Appeal 34817

Appeal Type: Building

Building/Business Name: City of Portland Columbia Boulevard Wastewater Treatment Plant Reuse Facilities

Proposed use: Rain and sun canopy for process equipment.

REUSE CANOPY
SECTIONS

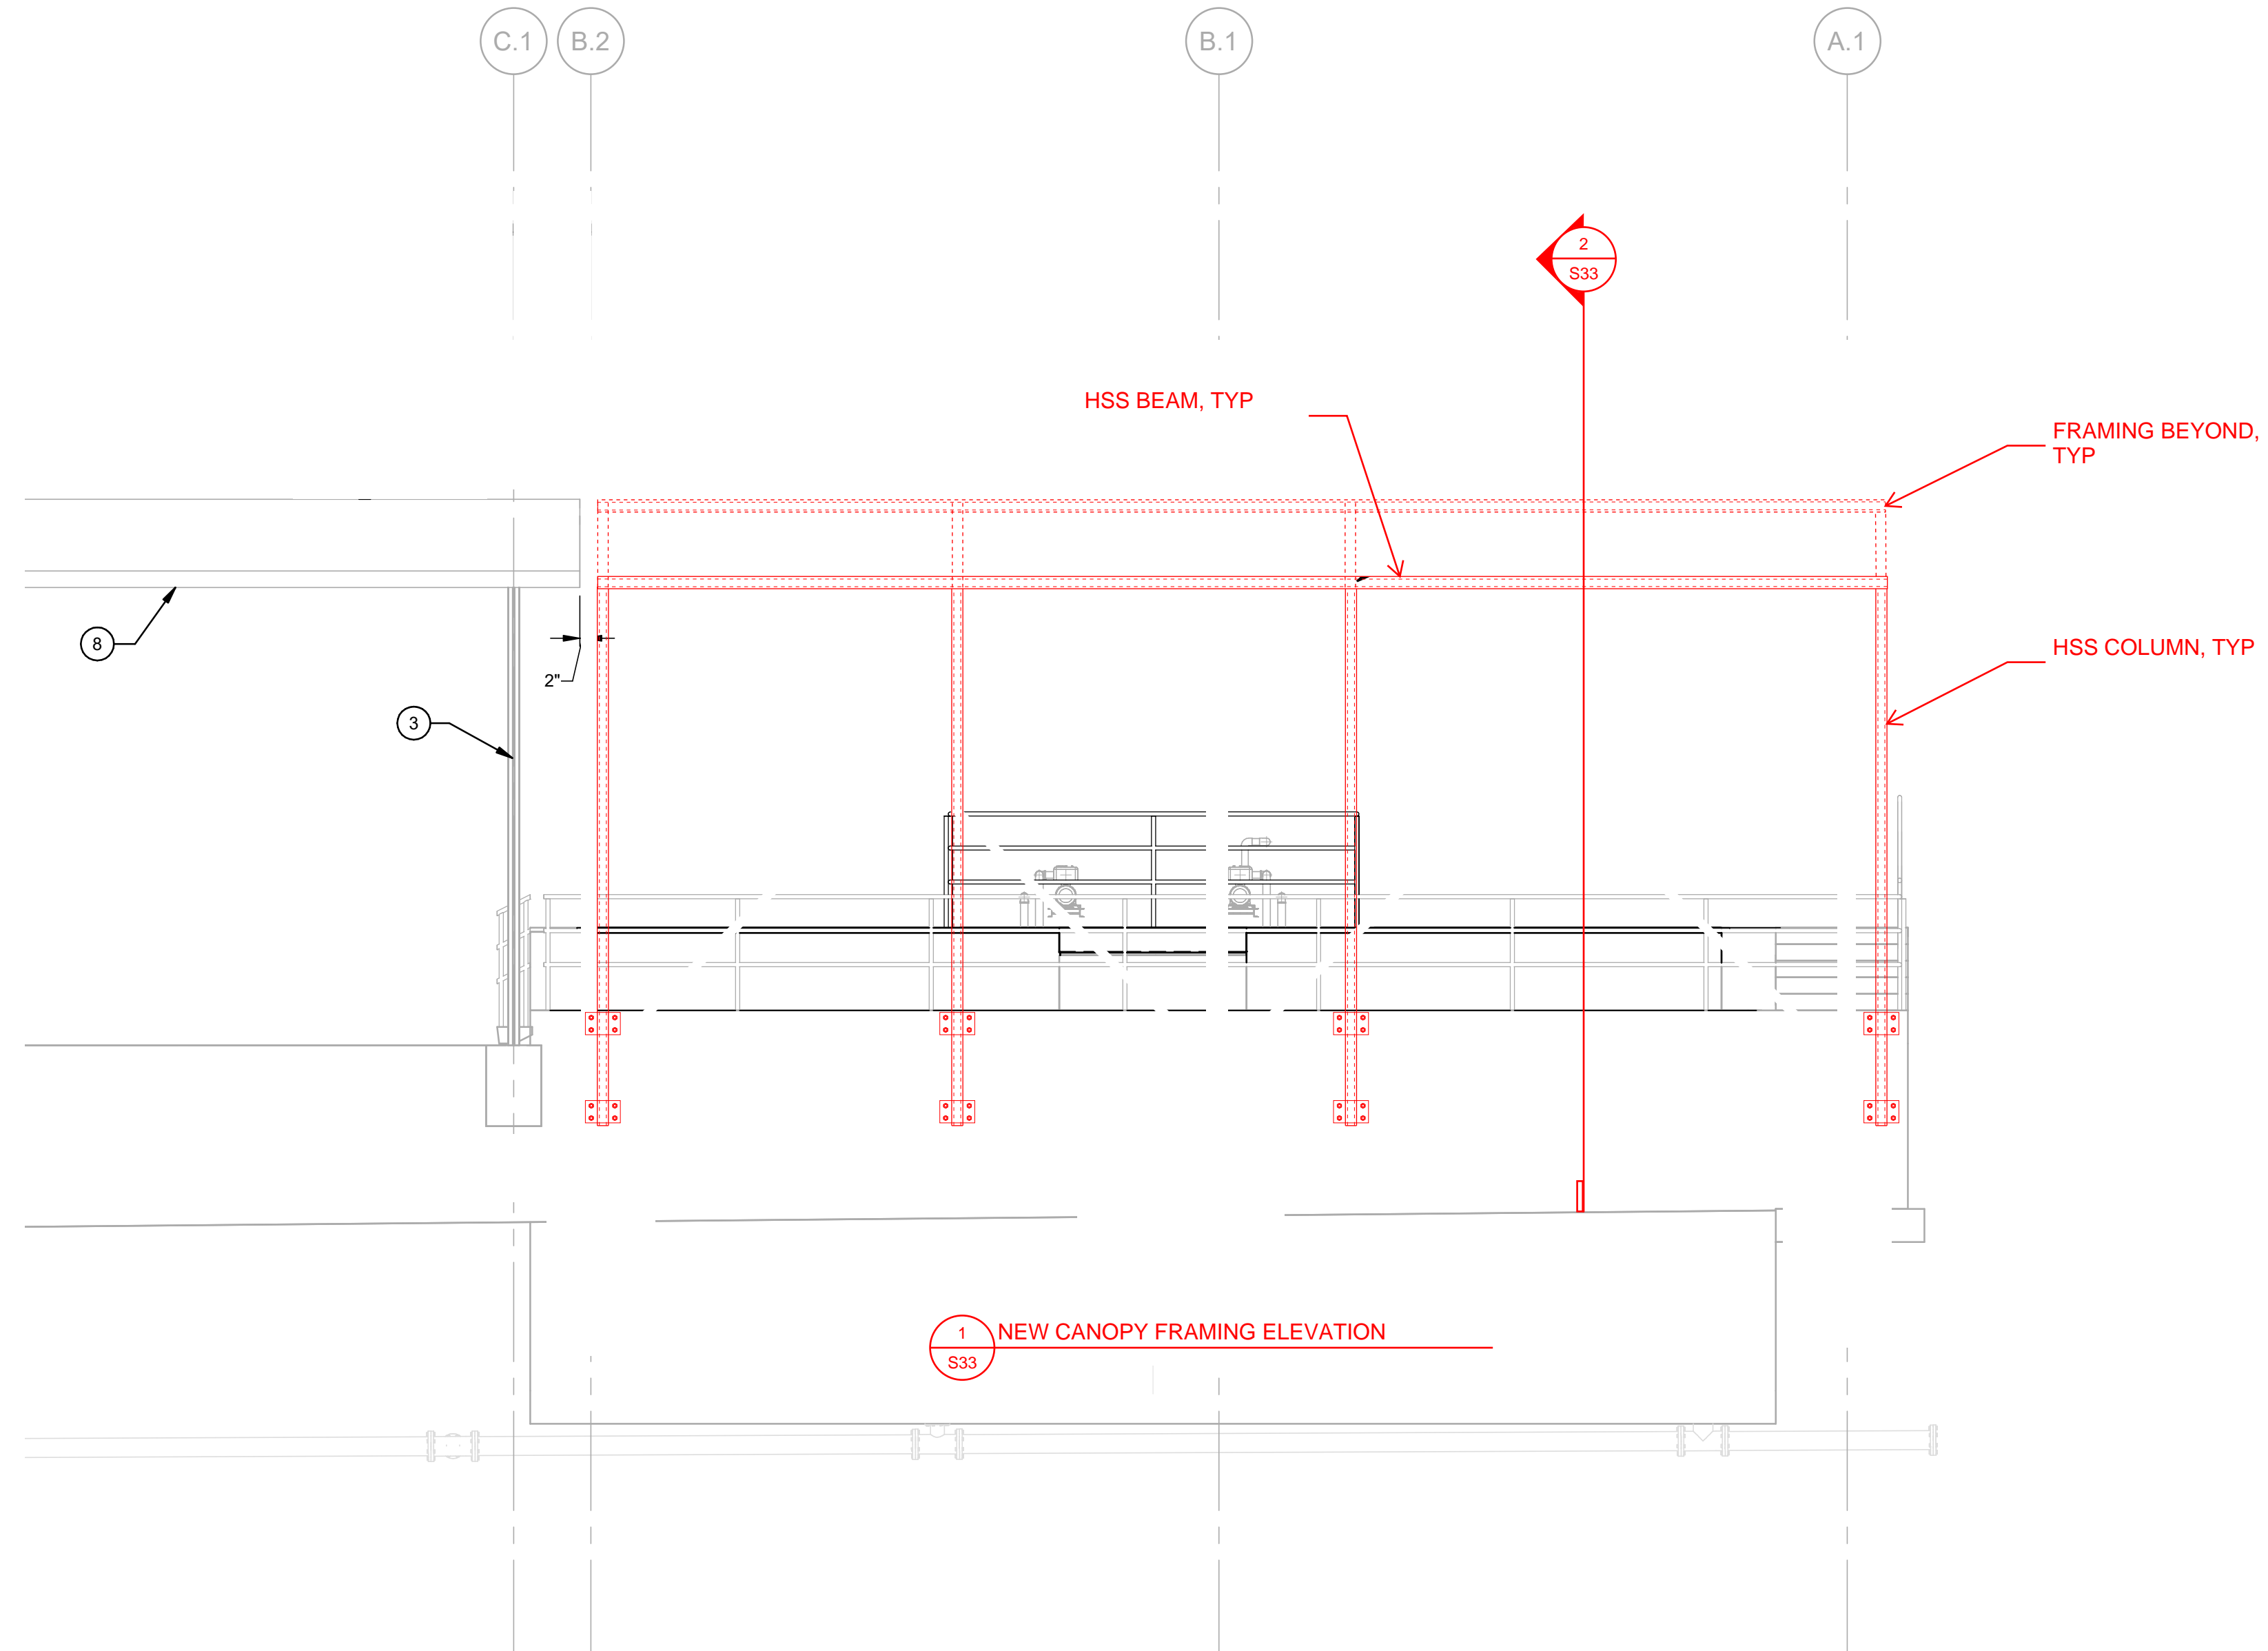
Due to the low risk to life safety, the intent of the appeal is to waive the requirements of ASCE 7-16 Section 12.13.9 on the existing concrete structure.

The proposed new open-sided steel-framed column and roof canopy structure will attach to the top and sides of the existing concrete structure, and the columns will cantilever upward to support the roof. No new foundations will be constructed, and there will not be any ground disturbance with the proposed design.

Since the change in the risk to life safety due to the infrequent occupancy is minimal, and the impracticality of rehabilitating the existing structure to address liquefaction issues, we propose that the steel framed canopy structure be allowed to be constructed as an addition to the western-half of

the existing concrete structure without provisions made to address ASCE 7-16 Section 12.13.9.

Waive the requirements for foundations on liquefiable sites for the construction of a new steel-framed canopy: Granted provided the post to roof framing connections of the canopy structure are ductile to accommodate rotations that the structure may experience due to differential settlement.
